LETTER OF INTENT
SETTLERS RANCH FILING 2D PHASE 4 REZONING APPLICATION

November 5, 2022

V1_Letter of IntentRedlines.pdf Markup Summary 12-6-2022

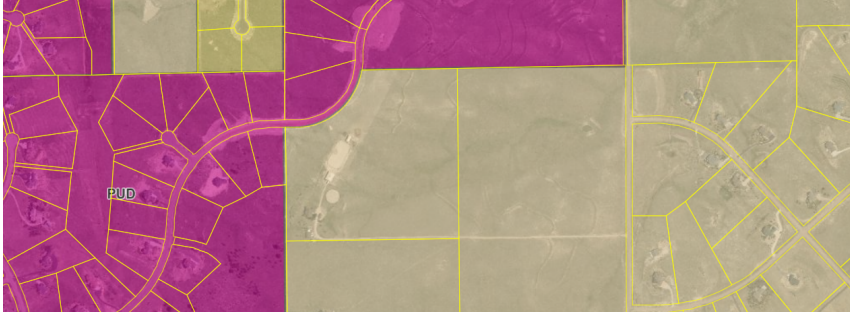
...the master plat is expired please just reference the PUD; the 10 lot 5 acre prelim plat are not relative to this rezone request, the PUD is as it is the current zoning

The master plat is expired please just reference the PUD; the 10 lot 5 acre prelim plat are not relative to this rezone request, the PUD is as it is the current zoning
